Voluntary Service
Campaign2025MY
EV6 (CV1a)

SC343 (Rev 1, 11/18/2025)

PDC LOGIC IMPROVEMENT AND PRA REPLACEMENT
FOR DTC P1B7700 (SC343)

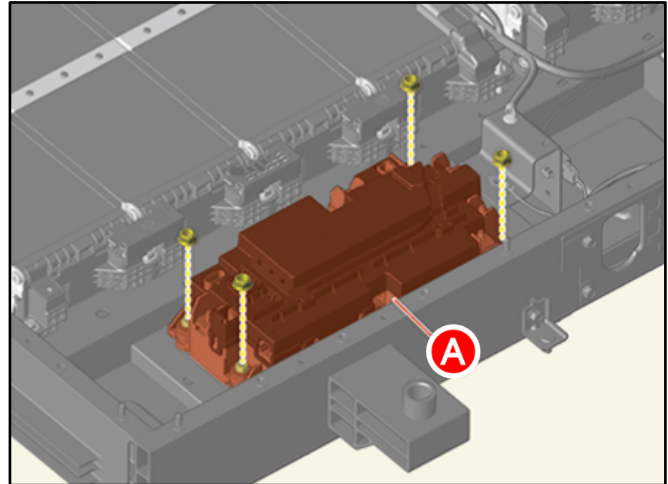
1. Replace the power relay assembly (PRA) (A) by referring to “Battery Control System → High Voltage Battery Control System → Power Relay Assembly → Removal and Installation” in the applicable Shop Manual on KGIS.

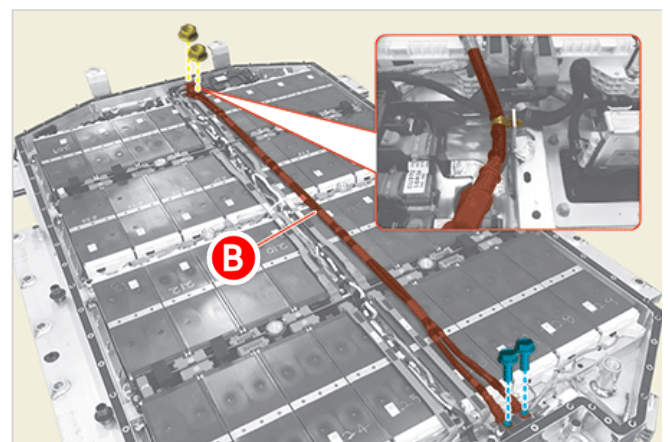
NOTE: The six (6) PRA Bus Bar (B) retaining bolts are not reusable. All bolts (x6) MUST be replaced with new parts.

Tightening torque for nut/bolt (X):
5.8 - 8.7 lb.ft (7.8 - 11.8 N.m)
